HISTORIC AREA WORK PERMIT CHECKLIST OF APPLICATION REQUIREMENTS

HOUSE LOCATION
PART OF LOT 15-BLOCK 7
LIPSCOMB AND EARNEST
TRUSTEES
ADDITION TO TAKOMA PARK
MONTGOMERY COUNTY, MARYLAND

APPROVED
Montgomery County
Historic Preservation Commission

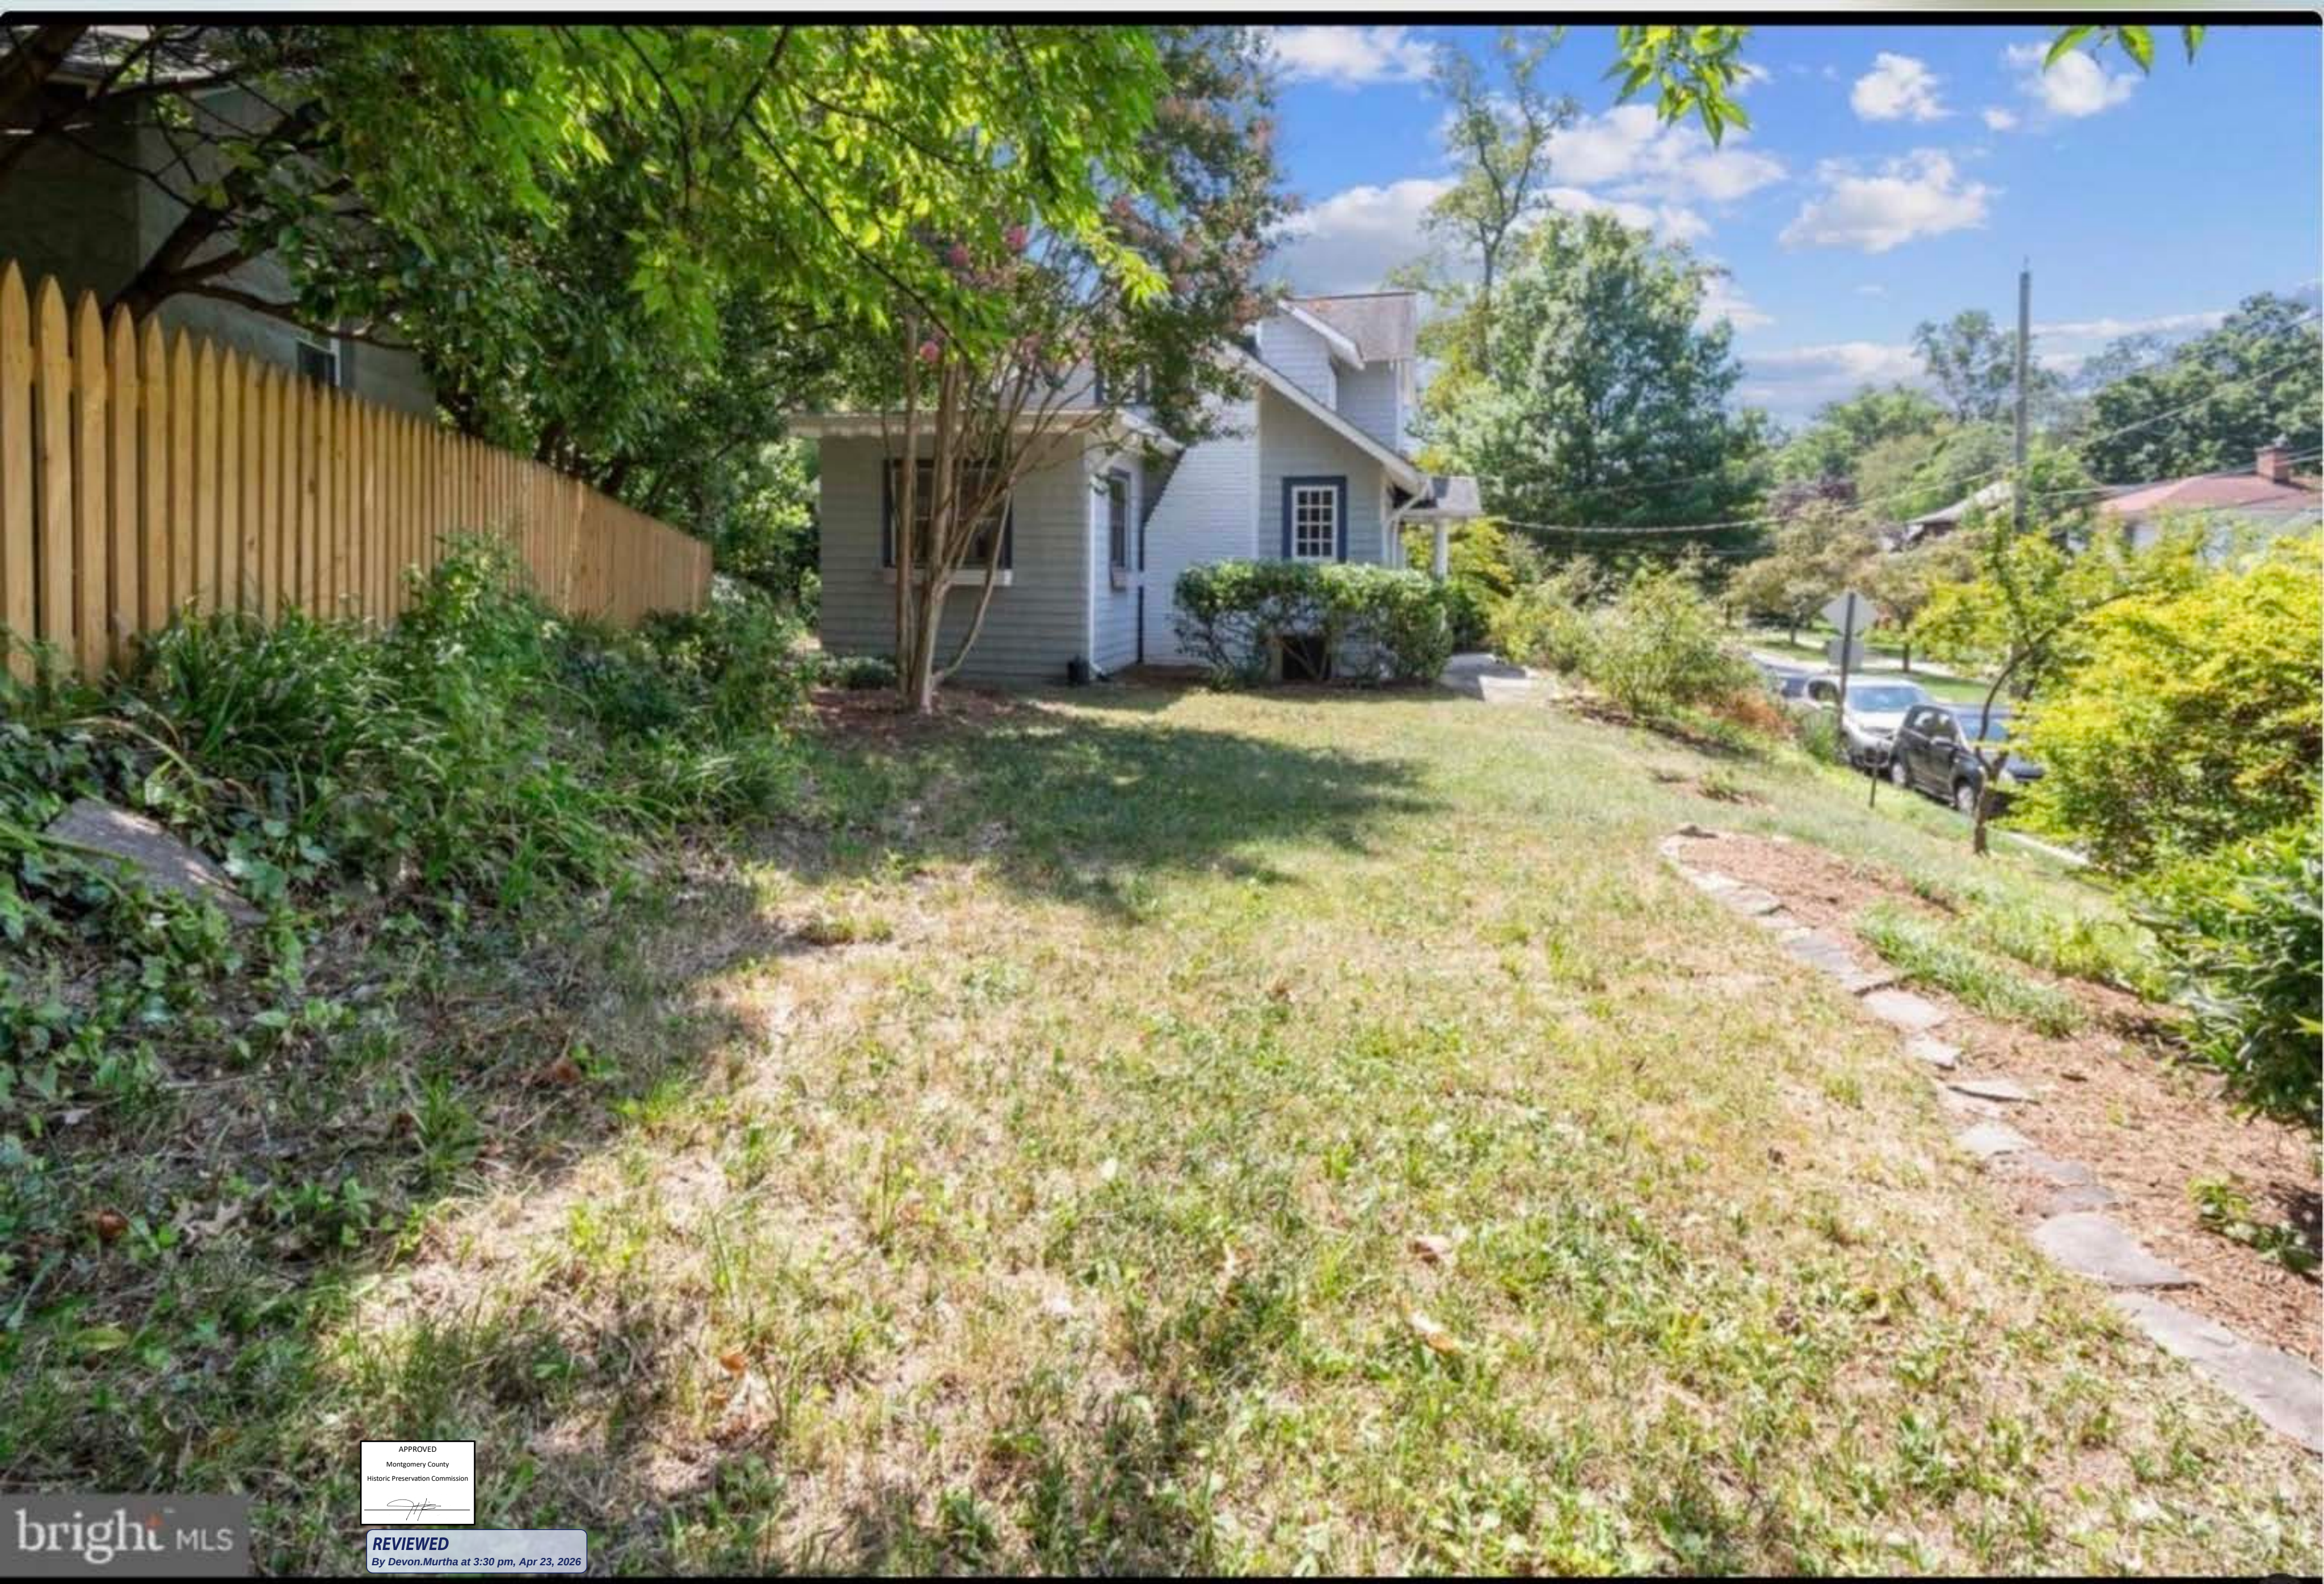
To summarize our conversation, I am just waiting on more specific details related to the proposed fencing and gates. In particular, please specify the exact sizes of everything to include heights, distance between posts, and proposed material between fencing (type of mesh - metal, plastic, etc). Please also send that information for the gate, including height and design. You might consider something that matches the overall appearance of the fencing, or a wood gate that is shorter than the proposed fencing.

Thank you Devon - that gate and fence in your photo seems fine. Material specs:

- Black coated welded wire mesh, 1 inch opening maximum
- Posts 8 feet on center
- 6 feet height
- 3 Gates 48 inches wide, 6' high like in your photo
